## Addendum No. 2

Project: Heroes Plaza  
Project Number PR-022-22

This Addendum forms a part of, and modifies, the Request for Quotes for the above referenced project. Acknowledge the receipt of this Addendum No. 2 and all subsequent Addenda, if any, in the space provided on the Quote Form. Failure to do so may subject Quoter to disqualification.

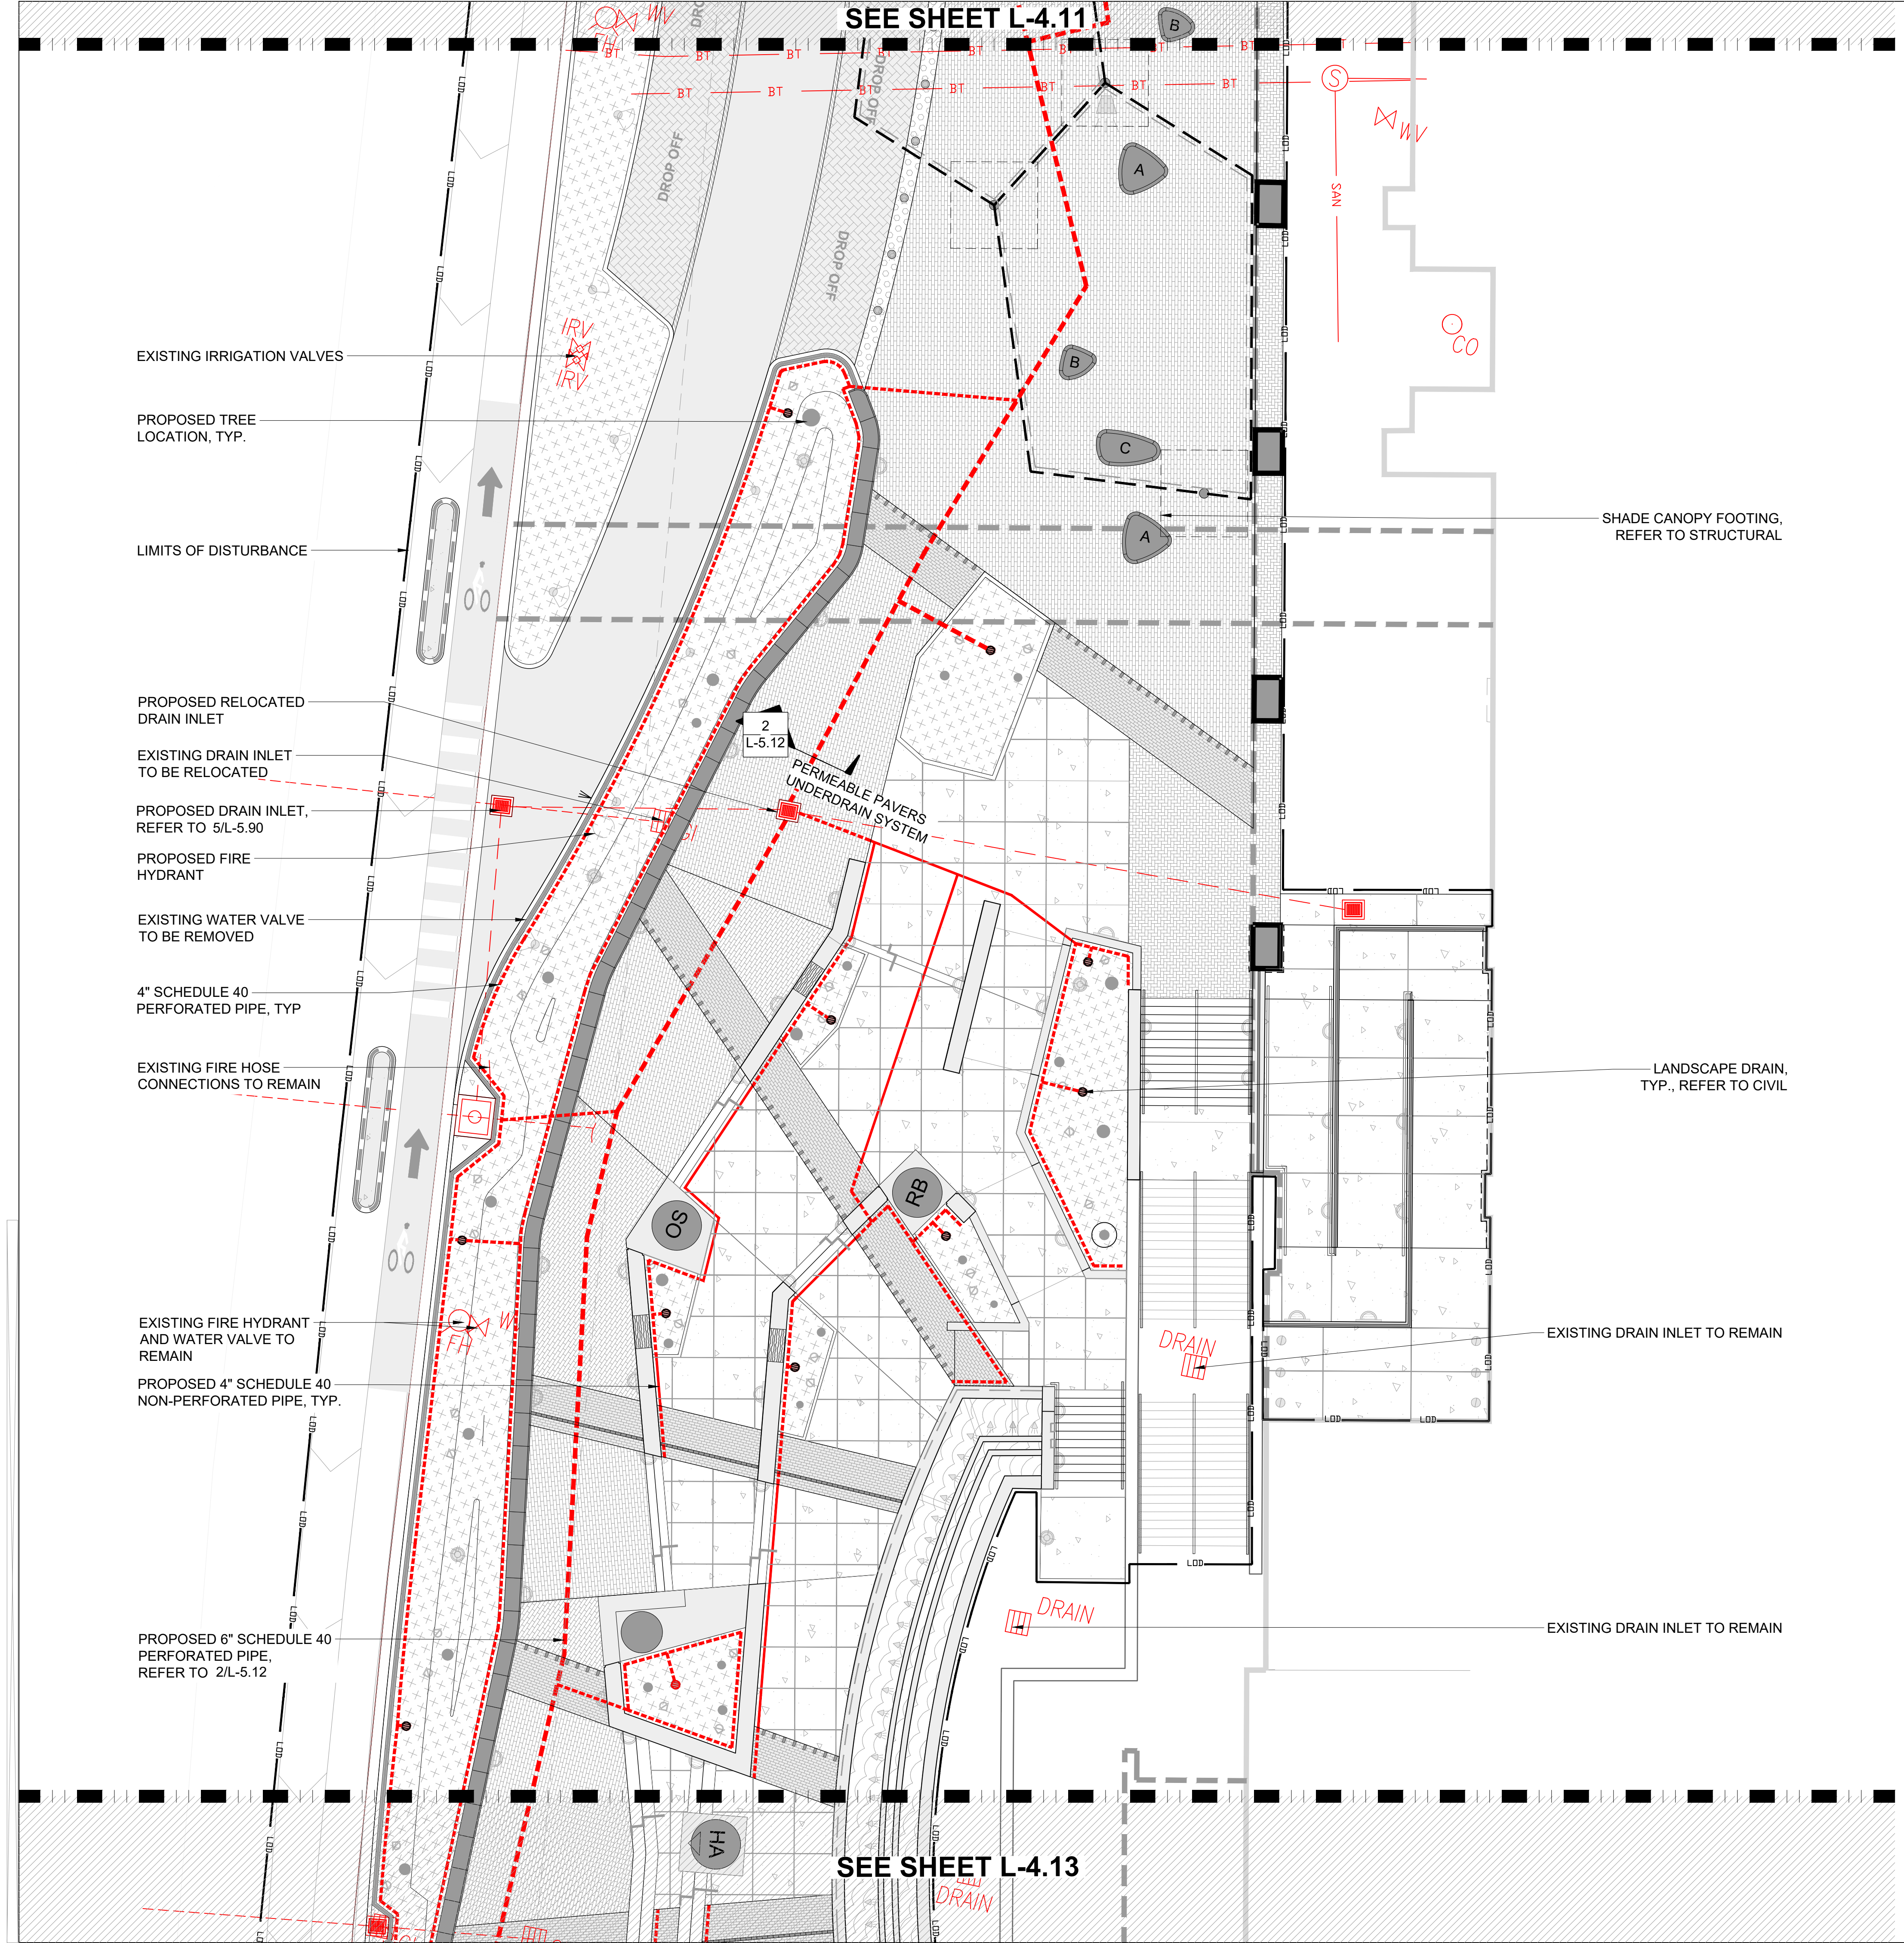
- Item 2 Question : Is there a specific thickness for the pedestrian concrete and the rock layer underneath it?  
Answer: Yes, 4" concrete thickness and 4" graded aggregate base. Refer to revised drawings included in this Addendum.

HARDSCAPE SCHEDULE					
DETAIL	MATERIAL	SPECIFICATIONS	NOTES	MANUFACTURER	IMAGE
1	PLAIN CONCRETE - PEDESTRIAN	TYPE: 3,000 PSI STANDARD CONCRETE WITH MICROMESH ADDITIVE. 4" CONCRETE THICKNESS, 4" AGGREGATE THICKNESS FINISH: BROOM FINISH CONTROL JOINTS: TROWELED COLOR: PLAIN GRAY	HARDSCAPE MATERIAL SELECTION NOTES: 1. SEE DETAIL 1/L-5.11 FOR DETAILS. 2. CONTRACTOR TO PROVIDE MOCKUP FOR APPROVAL.		
2	PLAIN CONCRETE - VEHICULAR	TYPE: 4,000 PSI STANDARD CONCRETE FINISH: BROOM FINISH COLOR: PLAIN GRAY LOCATION: SEE PLANS CONTROL JOINTS: TROWELED	HARDSCAPE MATERIAL SELECTION NOTES: 1. CONTRACTOR TO PROVIDE MOCKUP FOR APPROVAL. 2. SEE 2/L-5.11 FOR DETAIL.		
3	PEDESTRIAN PAVER	MANUFACTURER: HANOVER TYPE: PERMEABLE 4"x8" COLOR: CUSTOM COLOR SELECTED FROM THE MANUFACTURER'S FULL LINE OF COLORS. CONTRACTOR TO COORDINATE WITH LANDSCAPE ARCHITECT.	HARDSCAPE MATERIAL SELECTION NOTES: 1. CONTRACTOR TO PROVIDE MOCKUP FOR APPROVAL. 2. INSTALLATION PER MANUFACTURER'S SPECIFICATIONS. 3. SEE 1/L-5.12 FOR DETAIL.	CONTACT: HANOVER PHONE: (800) 426-4242
